**SUBJECT: COMANCHE PEAK STEAM ELECTRIC STATION (CPSSES)
DOCKET NOS. 50-445 AND 50-446
RESPONSE TO REQUEST FOR ADDITIONAL INFORMATION
RELATED TO LICENSE AMENDMENT REQUEST 05-007,
REVISION TO TECHNICAL SPECIFICATION 5.6.6 REGARDING
PRESSURE AND TEMPERATURE LIMITS REPORT (PTLR)
TAC NOS. MC9500 AND MC9501**

**TXU POWER RESPONSE TO
REQUEST FOR ADDITIONAL INFORMATION**

**LICENSE AMENDMENT REQUEST 05-007
REVISION TO TECHNICAL SPECIFICATION 5.6.6 REGARDING
PRESSURE AND TEMPERATURE LIMITS REPORT (PTLR)
COMANCHE PEAK UNITS 1 AND 2
TXU GENERATION COMPANY, LP
TAC NOS. MC9500 AND MC9501**

**COMANCHE PEAK STEAM ELECTRIC STATION (CPSES)
PRESSURE AND TEMPERATURE LIMITS REPORT
(APPLICABLE UP TO 36 EFPY)**

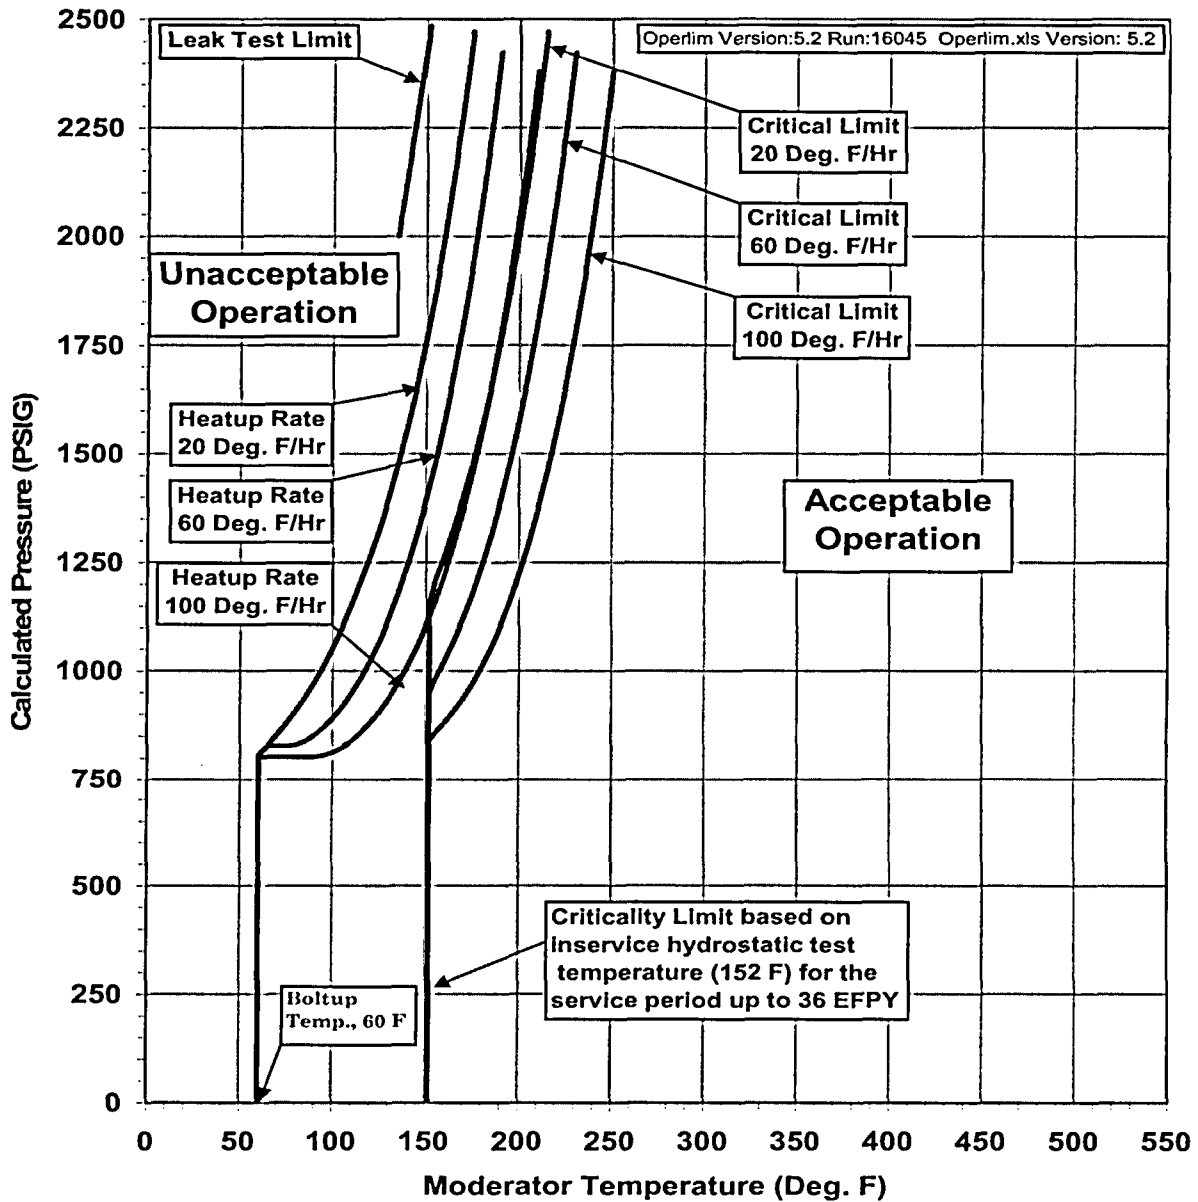
Generic Letter (GL) 96-03 requires that: (1) a PTLR shall identify both the limiting adjusted reference temperature (ART) values and limiting materials at the 1/4t and 3/4t locations and (2) a PTLR for pressurized water reactors (PWRs) shall identify the reactor pressure vessel's (RPV's) limiting reference temperature (RTPTS) value in accordance with Title 10 of Code of Federal Regulations Part 50, 50.61. Please revise your PTLR to include the limiting ART values and limiting materials at the 1/4t and 3/4t locations for Unit 2. Further, the RPV's limiting RTPTS values for both units shall also be included in the PTLR. Lastly, it appears that you propose to use one set of pressure-temperature (P/T) limits to bound those for both units. If this is the case, a footnote on PTLR Figures 2-1 and 2-2 to indicate this approach would clarify your intention.

The title for Figure 2-2 contains an editorial error. The word "Heatup" in the title should be revised to "Cooldown."

- (1) The revised PTLR, attached to these responses, identifies the limiting ART value and material at the 1/4t and 3/4t locations for each reactor vessel.
- (2) The RTPTS values and bases for each unit are included in the revised PTLR, attached to these responses.
- (3) An appropriate notation to include the suggested information has been added to Figures 2-1 and 2-2 of the revised PTLR, included with these responses.

The title has been corrected in the revised PTLR, included with these responses.
